March 10, 2014

The Bluewater Valley Downstream Alliance (BVDA), a core member of the Multicultural Alliance for a Safe Environment (MASE), hereby submits the following comments regarding a proposed amendment to the radon monitoring program at the Homestake-Barrick Gold Uranium Mill Tailings site north of Milan, New Mexico. The proposed amendment was brought to BVDA/MASE attention via a letter from the NRC. No one from the NRC offered to meet with members of our community or offered to explain what this proposed change might mean for our community members, who have been living over 40 years now with radon in the ambient air that, according to a recent USEPA Human Health and Risk Assessment draft report, is five times the EPA limit and represents 18 times the EPA's acceptable lifetime cancer risk standards.

For the reasons given below, BVDA requests the NRC staff deny Homestake-Barrick Gold's (H-BG) application to change the location of its background radon monitor.

Figure 4-1 Predicted transport of on-site sources of radon normalized to HMC-4 and HMC-5 average

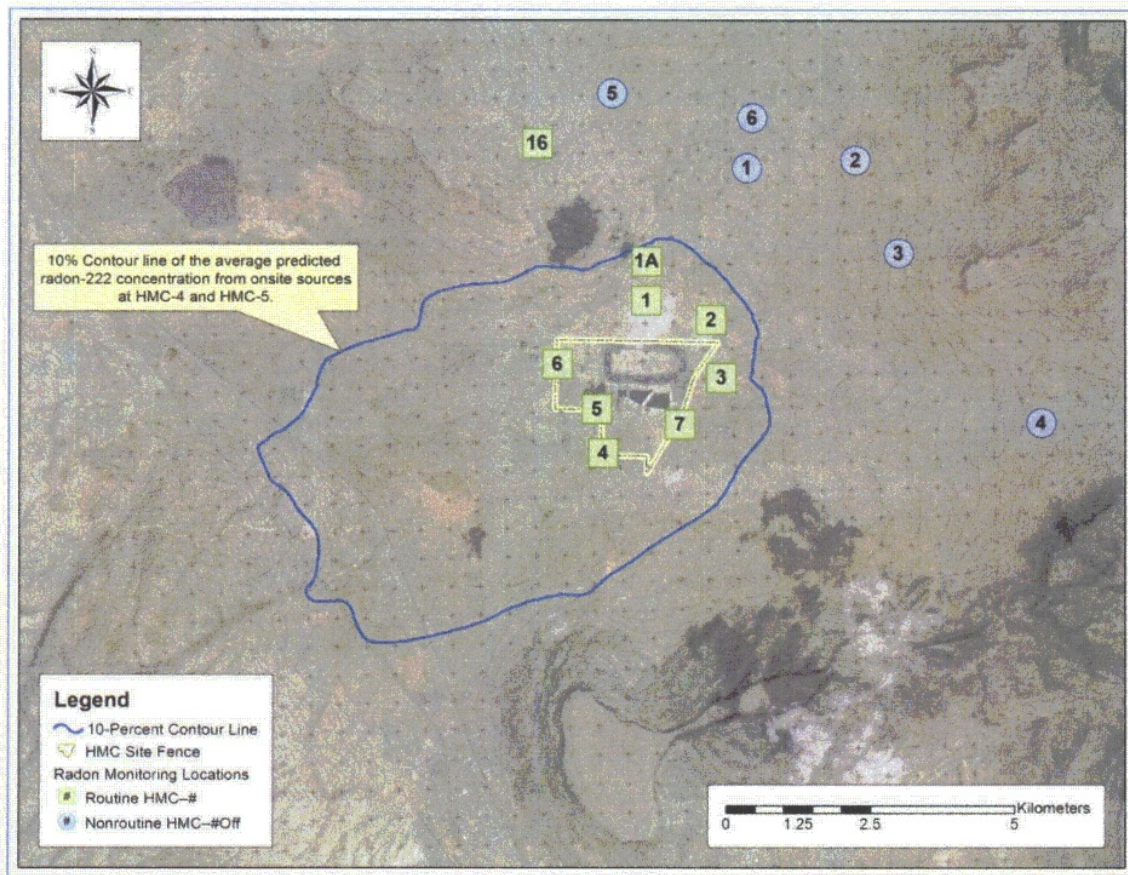
The amendment proposes to change the radon monitoring array used at the Homestake tailings site by replacing the radon monitoring site used as the baseline data source for NRC license purposes for more than two decades, named HMC-16, located about 3 miles north-northwest of the tailings, with a radon monitoring site located about 2 miles east of HMC-16 (“16” in “green square”) and about 2 miles north-northeast of the large tailings pile, named HMC-10ff (“1” in “blue circle”) as shown in the figure below.

In brief, H-BG’s Analysis supporting this proposed change asserts that HMC-16 may “underestimate background” and HMC-10ff would not.

Table 4.2 of the HMC consultants' report shows that Rn levels at location HMC-10ff are as high as ambient levels at the two monitors closest to the community -- HMC-4 and HMC-5 -- which, historically, have had the highest levels and therefore demonstrate substantial lung exposure risks to the people living closest to the large tailings pile. The consultants' report presents no data on soil uranium or radon levels at the HMC-10ff location. Wind rose patterns in the consultants' report, presented previously by Homestake-Barrick Gold, clearly show that the 10ff site would be in the direction of the most frequent winds, on the order of 8% to 10% of the time.
